## ***KM/CS-3050/4050/5050 Firmware Release Notes***

<b>Subject:</b>	<b>Firmware Update</b>
<b>Model</b>	<b>KM/C-3050/4050/5050</b>
<b>Updated Machines Serial Number:</b>	<b>N/A</b>

**The Combined Firmware is updated to Version 2.20C 09/08**

### **Change on displaying and resetting of C6020 (Abnormally high fuser unit Thermistor temperature)**

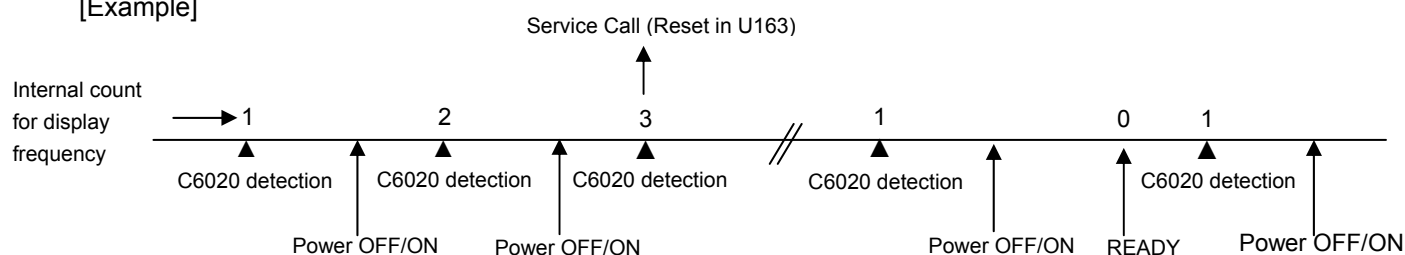
The displaying and resetting of C6020 (Abnormally high fuser unit thermistor temperature) has been changed as illustrated below.

- If a C6020 is detected, it will be displayed as a system error and can be reset by turning the power OFF and then ON. (Up to two times)
- The third time when a C6020 is detected, it will be displayed as a service call. (Please reset it in maintenance mode U163.)

The number of occurrence will be reset (to "0") when the main unit enters ready mode.

### **2. Document Box Improvements**

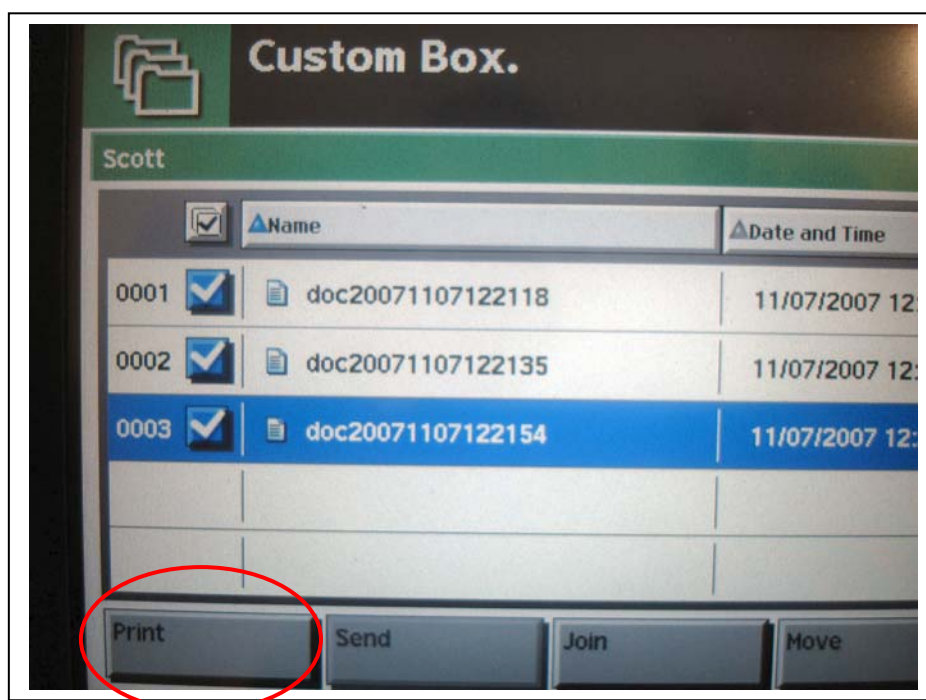
It is now possible to select multiple Jobs when printing from a Custom Document Box.

The Print Function is not available when Multiple Documents are selected to Print with previous Firmware.

The example below shows the Print Function is available when Multiple Documents are selected to Print, after upgrading to Version 2.04C Firmware.
